Ref: 29011.00

Re: MDP and Site Plan Phase 1 Comments
Silo Ridge Resort Community
Amenia, NY

On behalf of our client, Silo Ridge Ventures, LLC., "the Applicant", VHB Engineering, Surveying and Landscape Architecture, P.C. (VHB) offers the following responses to your comments dated October 17, 2014 (numbered in accordance with your letter).

PROJECT NAME:	SILO RIDGE ROUTE 22 CULVERT INSPECTION
FILE NAME:	Plan View.dgn
PROJECT LEADER:	K. POWERS
PLOT DATE:	1/12/2015
DRAWN BY:	A.J.D.
CHECKED BY:	K.B.P.
FIGURE	1

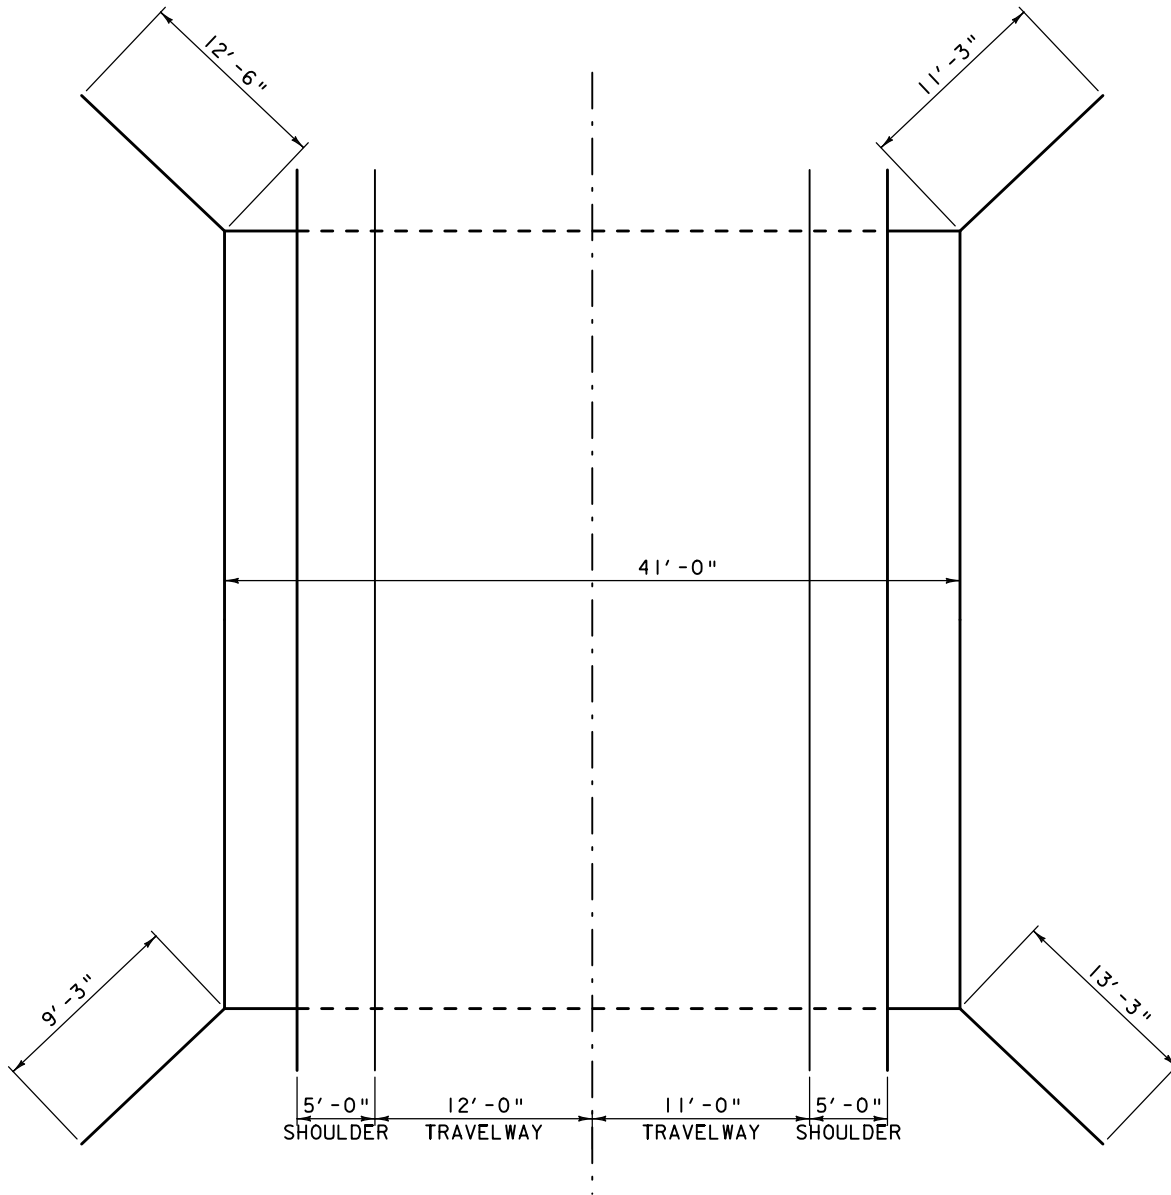
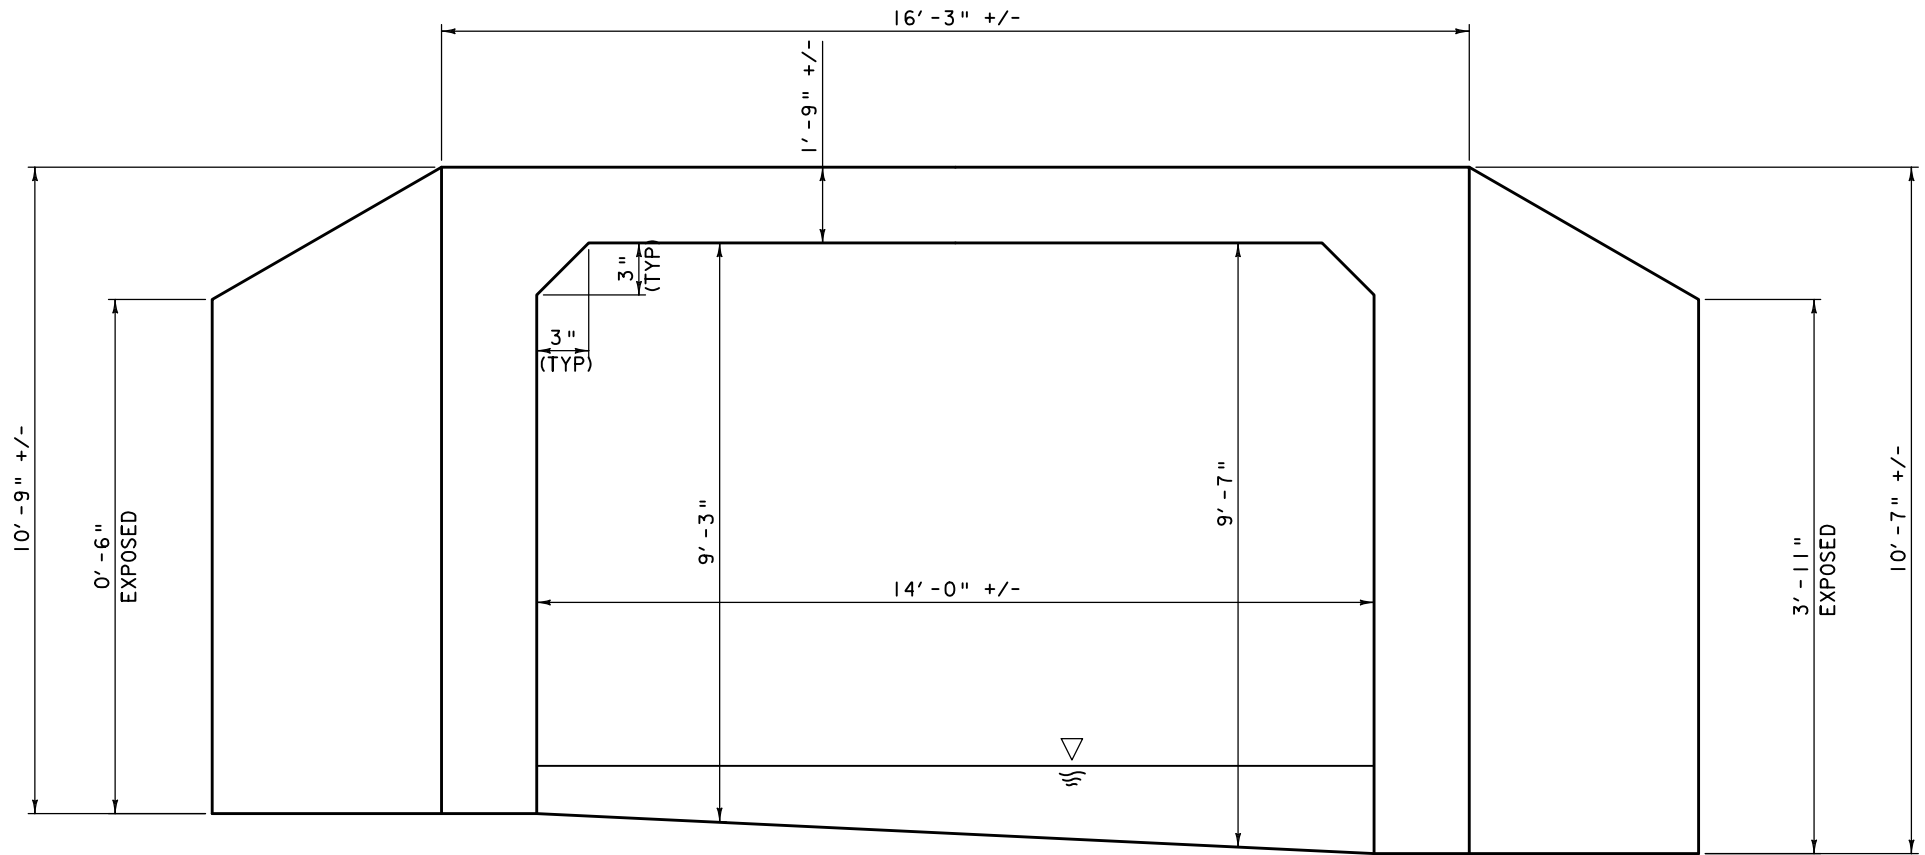
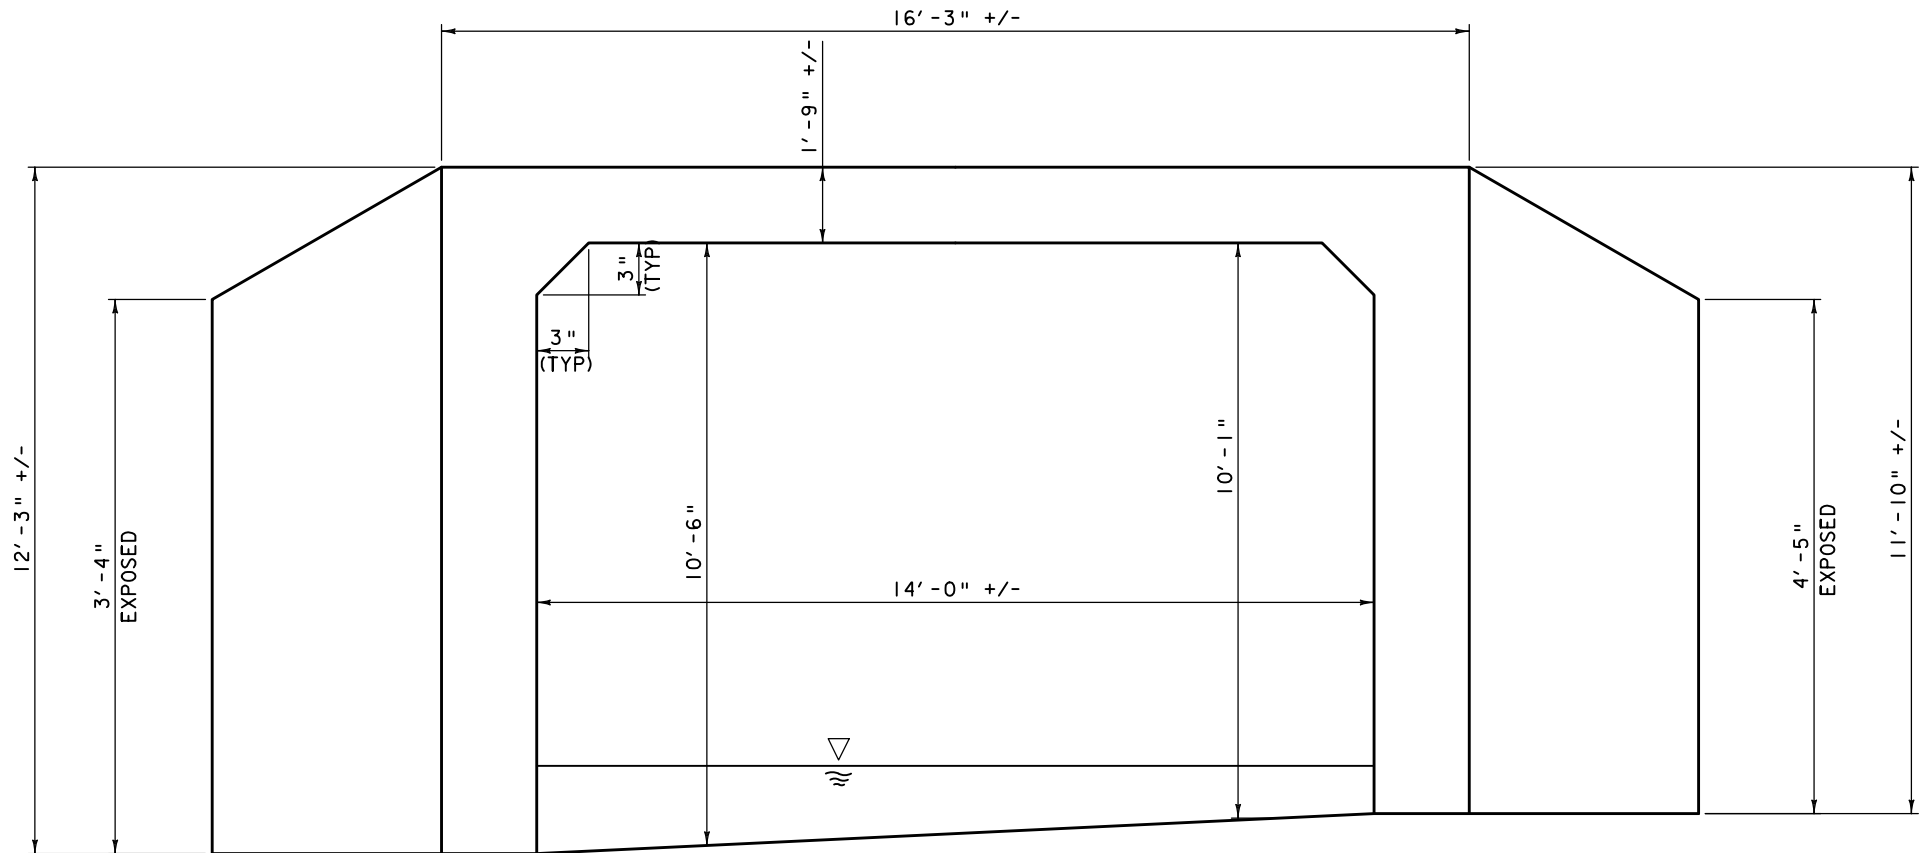
23. Comment: In reference to Drawing 2, the condition of the large cross culvert on RTE 22 must be confirmed. This culvert is located north of the proposed main entrance on RTE 22.

Response: VHB performed an inspection of the large cross culvert under Route 22 in December 2014. Please refer to VHB Memorandum dated January 13, 2015, (Attachment B), which provides a detailed assessment of the condition of the culvert. As indicated in the Memo, the structure is in overall fair condition, with some areas exhibiting spalling. The structure was last inspected by

NYSDOT on October 24, 2013 when it received a condition rating of 5.29 on a scale of seven (7.0), with seven being new or like new construction.

Not Approved for Construction
Drawing Title
General Plan 1

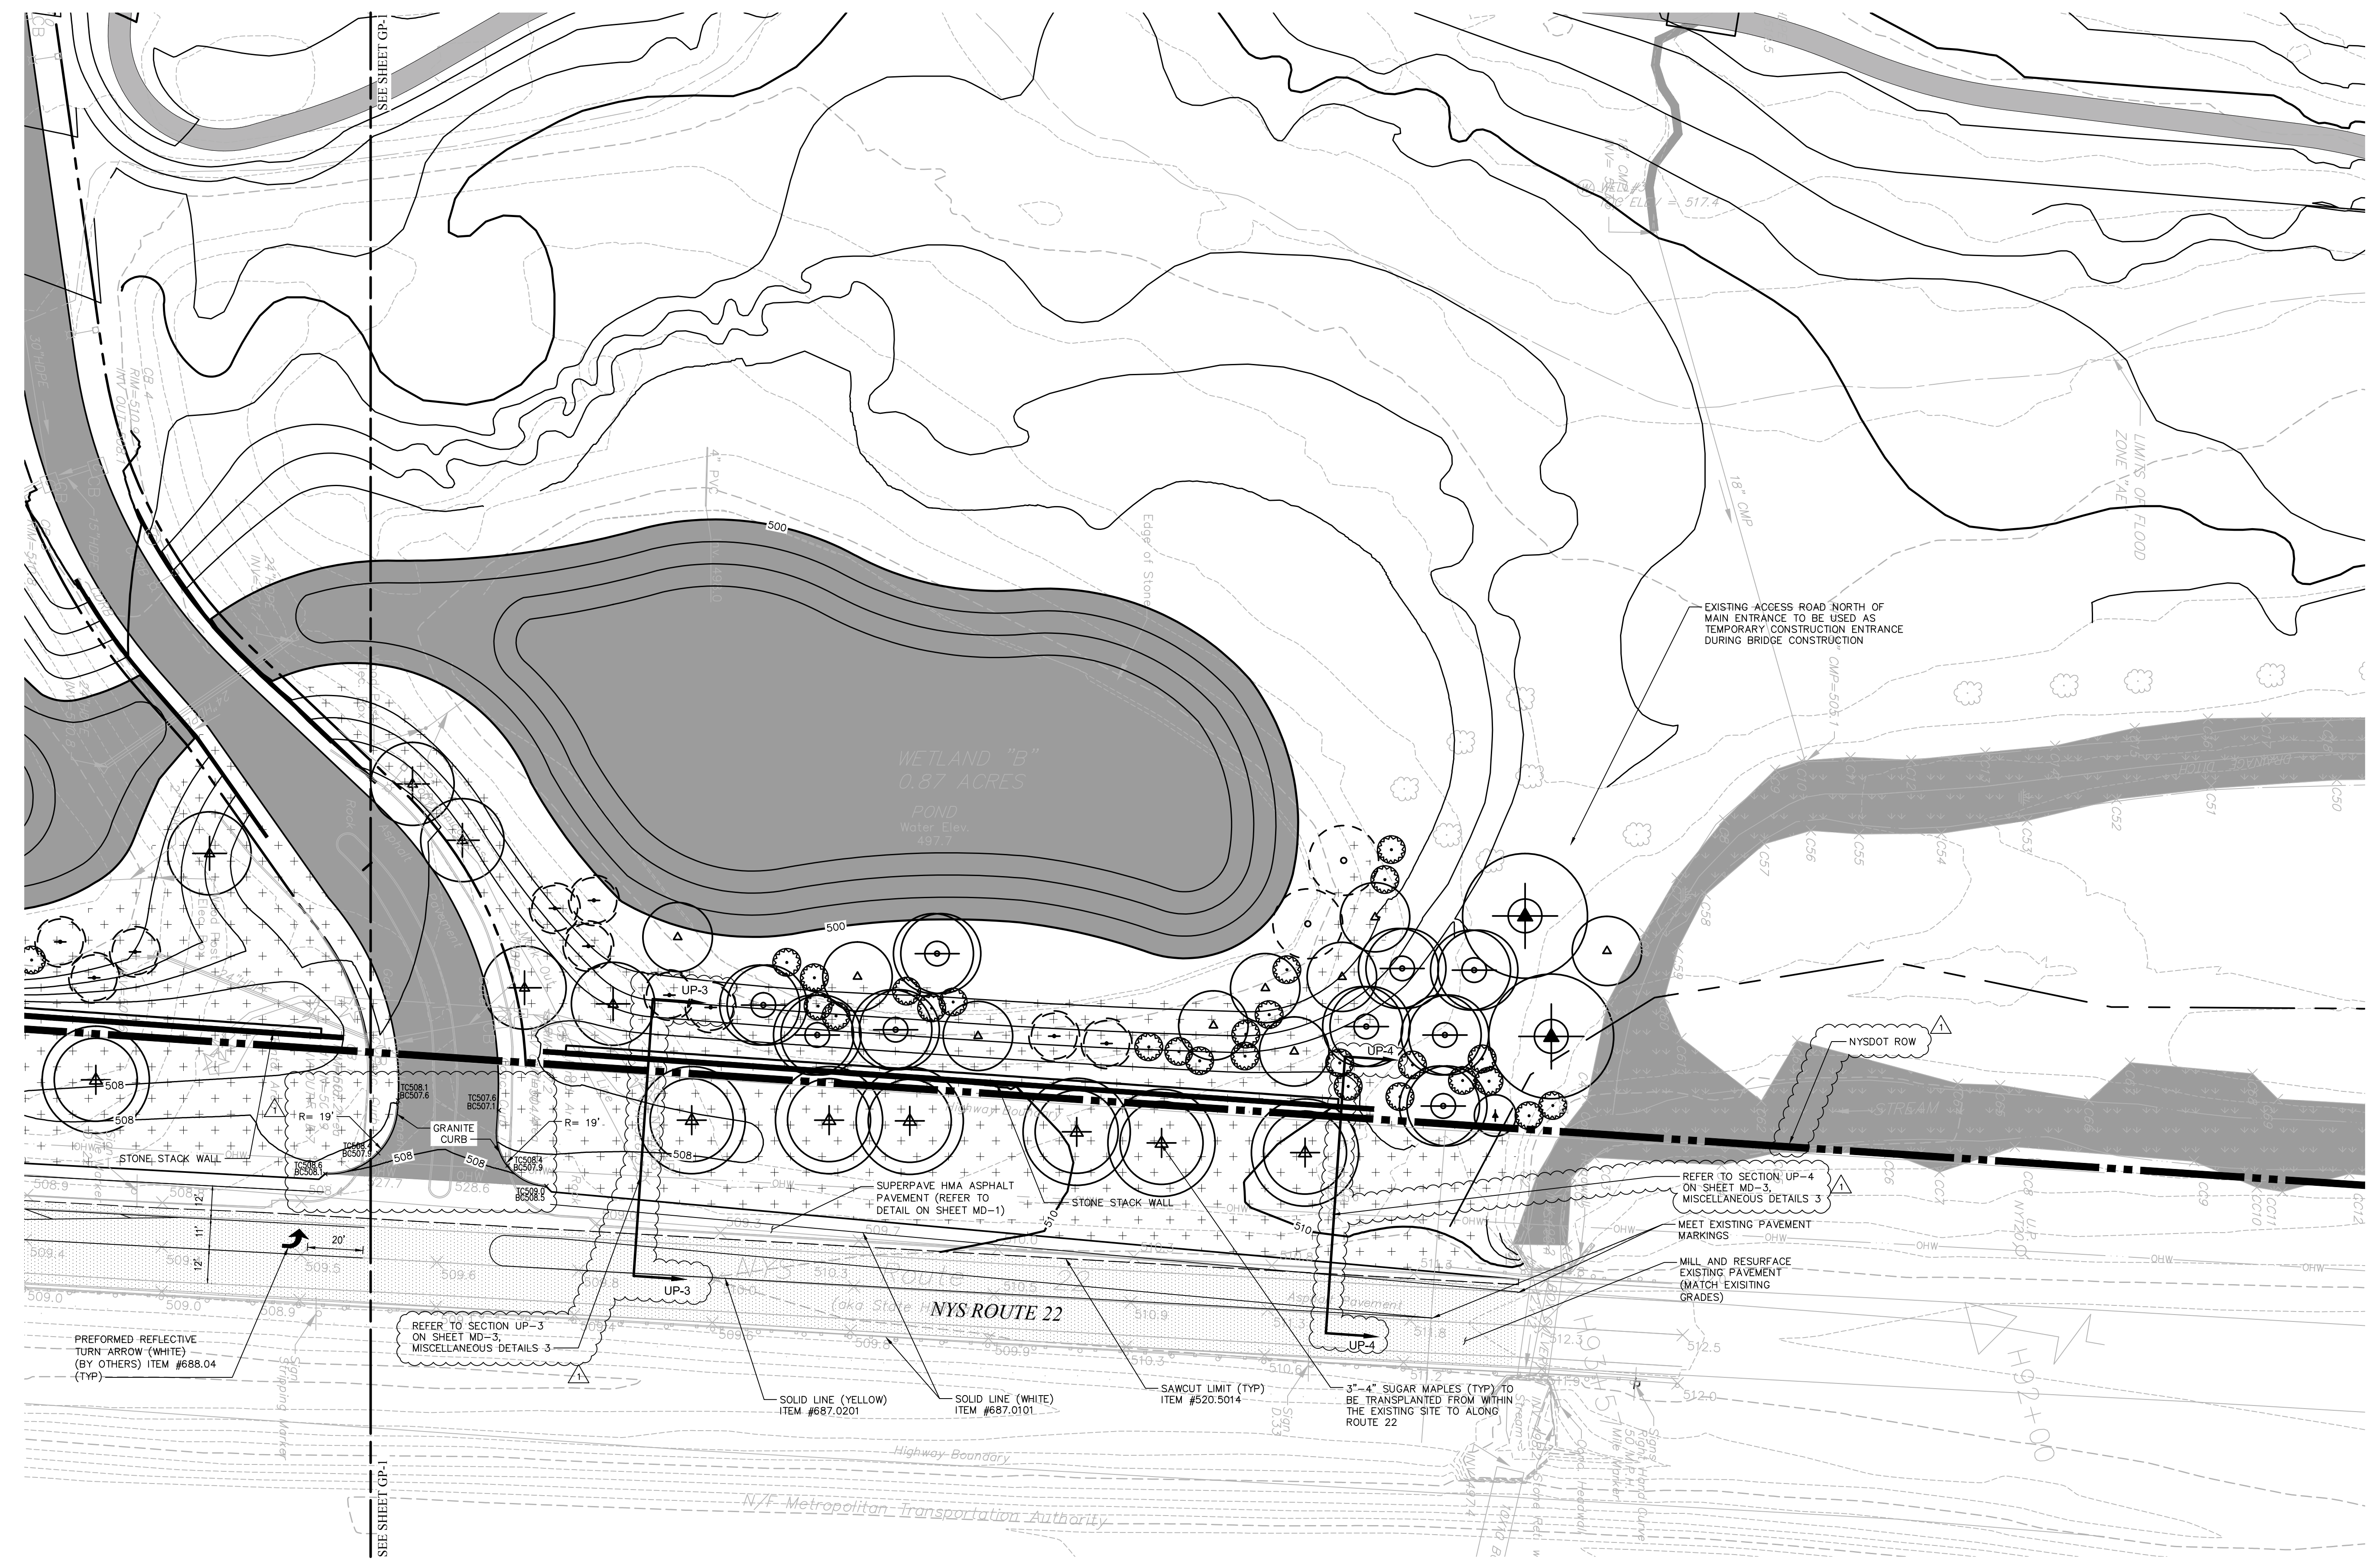
3. Comment: At one time, it was understood that a fill operation was planned within the right-of-way at either side of the main entrance. This is not evident on the plans. A confirmation is requested.

21. Comment: One of the proposed Sugar Maples appears to be located within the clear distance (w/in 30' of the travel way). This tree should be moved so that is a minimum 30' from the white line.

Response: The area of fill proposed within the right-of-way is adjacent to the main entrance on Route 22, as shown in plan view on drawing GP-1, General Plan 1 and GP-2, General Plan 2, dated January 8, 2015. Cross sections have been taken at four locations at the main entrance, as shown on drawing

Response: The tree has been relocated to be greater than 30 feet from the white line, as indicated on sheet GP-1, General Plan 1, dated January 8, 2015.
